# Fast link recovery proposal v2.0

12/7/2009

Gavin Parnaby

# Add fast retrain state diagram to 55.4.6

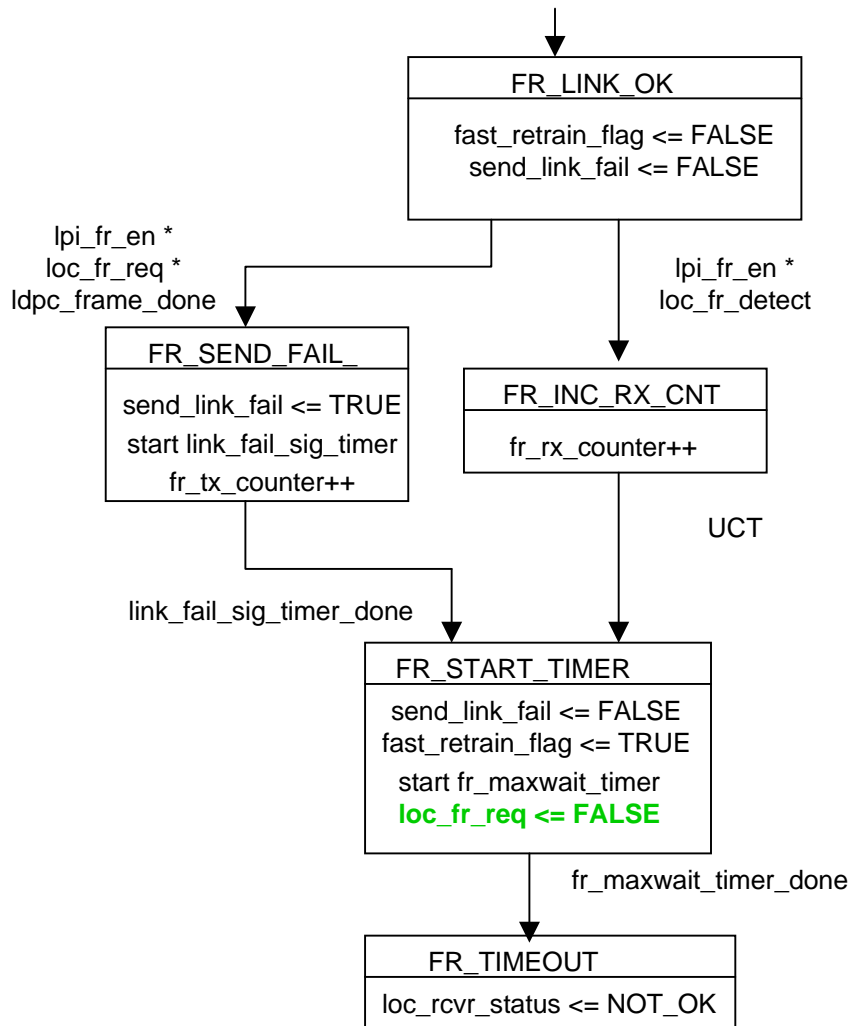
$tx\_mode = (SEND\_N * !loc\_fr\_req * !loc\_fr\_detect) + !lpi\_fr\_en$

- Add a variable **loc\_fr\_req**
  - when set indicates the local PHY has detected a link failure
  - set through the refresh monitor state diagram and optionally through other vendor-specific means. It causes a transition to FR\_SEND\_FAIL, sending the link failure signal to the link partner.
- Add a variable **loc\_fr\_detect**
  - set true when the link failure signal is reliably detected in the PMA
- In FR\_START\_TIMER both sides of the link set fast\_retrain\_flag<=TRUE
  - to send the PHY control state machines back to PMA\_Coef\_Exch
- fr\_maxwait\_timer is fallback in case fast retrain fails
  - loc\_rcvr\_status <= NOT\_OK forces full retrain
  - PCS\_Status=OK sends state machine back to FR\_LINK\_OK

Figure 55-24—PHY Control state diagram

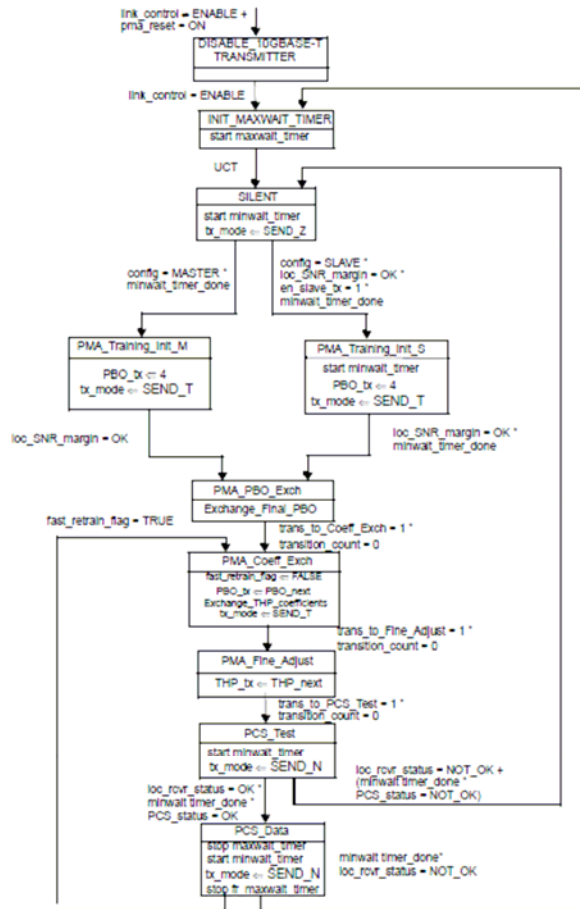
# Fast retrain : changes to Fig 55-24

- Re-enter at PMA\_Coeff\_Exch
- PAM2 signaling eliminates slicer errors
- Robust training
- Reuse existing states and transition protocols
- Minimize new text

Figure 55-25—MASTER transition counter state diagram

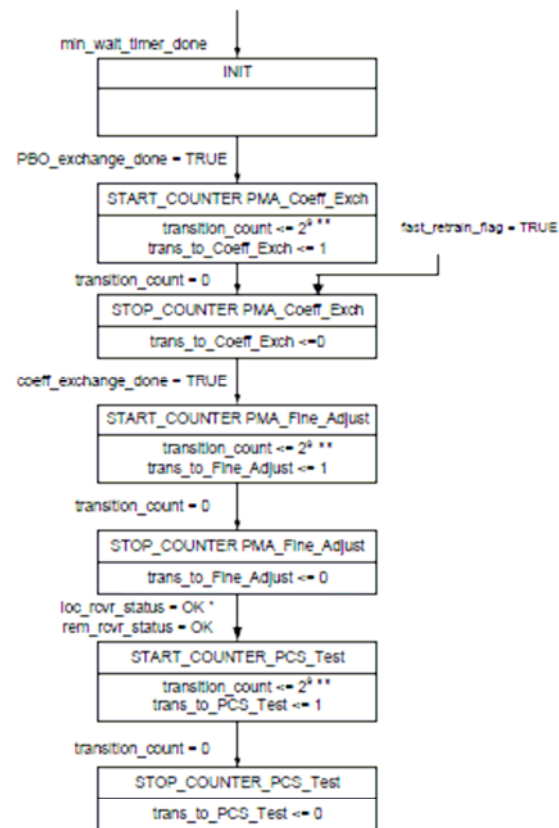
# Figure 55-25 changes

\*\* - devices supporting fast retrain use  $2^5$

Figure 55-26—SLAVE transition counter state diagram

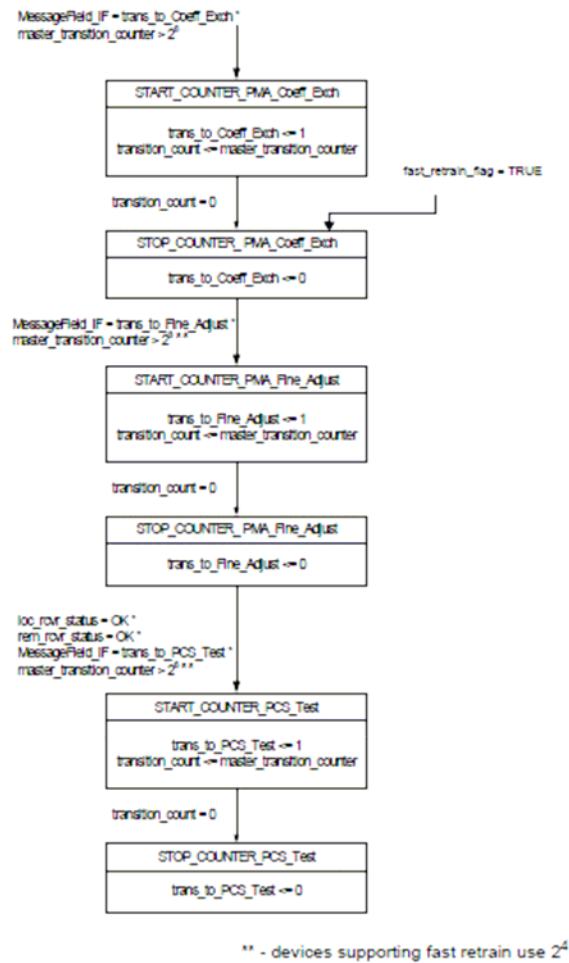
# Figure 55-26 changes
